SB-10058325-1132

2013-2014 C-MAX

This article supersedes TSB 14-0155 to update the vehicle model lines and Service Procedure.

Technical Service Bulletin Title: 2013-2014 C-MAX – Discharged 12 Volt Battery

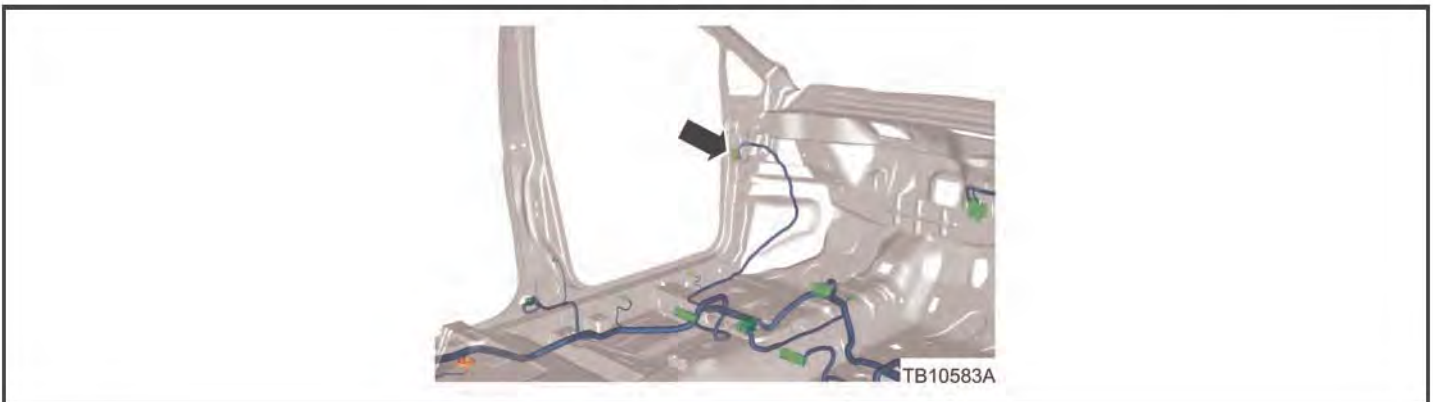
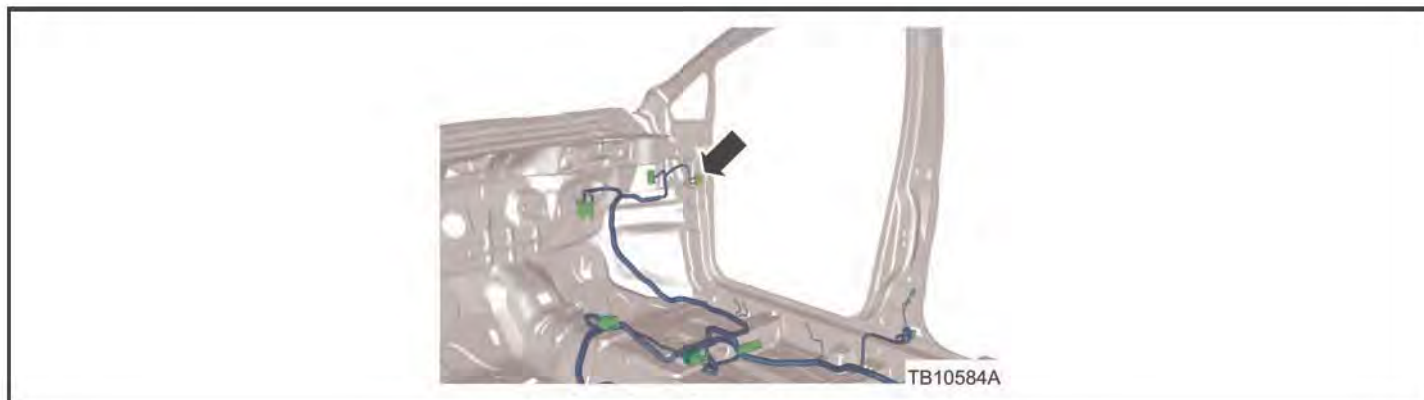
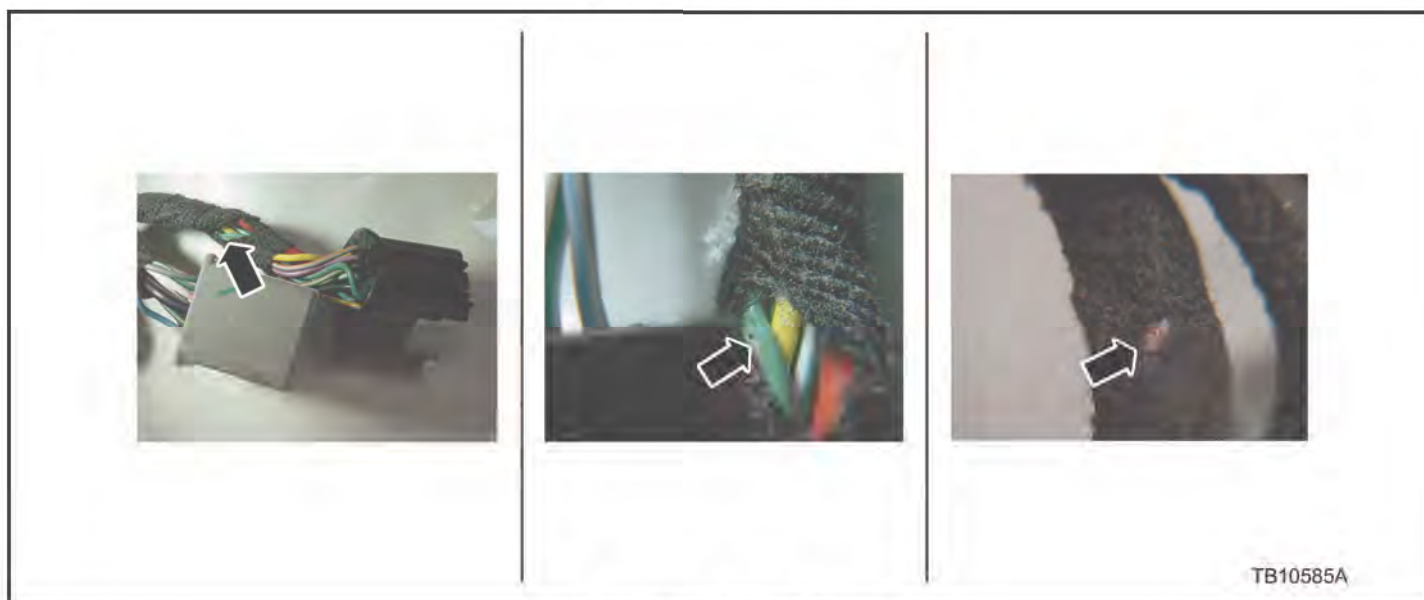
5. Was the vehicle built on or before 9/12/2013?
 - a. Yes - replace the telematics control unit (TCU) module. Refer to WSM, Section 415-00. Proceed to Step 6.
 - b. No - proceed to Step 6.
6. Was the vehicle built on or before 6/3/2013?
 - a. Yes - proceed to Step 7.
 - b. No - proceed to Step 8.
7. Inspect the wiring for damage or chafing in the rear liftgate area, driver door connector wire harness C339, and front passenger door connector wire harness C340 (Figures 1, 2, 3 and 4). Is damage or chafing present?

- a. Yes - repair the circuits as needed. Refer to Wiring Diagram (WD), Section 5-1. After repair, wrap the affected area with 3M™ Temflex™ Cotton Friction Tape or equivalent to prevent future concerns. Proceed to Step 8.
 - b. No - wrap affected area with 3M™ Temflex™ Cotton Friction Tape or equivalent to prevent future concerns. Proceed to Step 8.
8. Print the information sheet and provide to the customer. Communicate to the customer that Ford recommends disconnecting any devices attached to the auxiliary power port, USB port and OBDII port when the vehicle is turned off (such as cell phone chargers, USB devices, insurance company snapshot devices). (Figure 5)
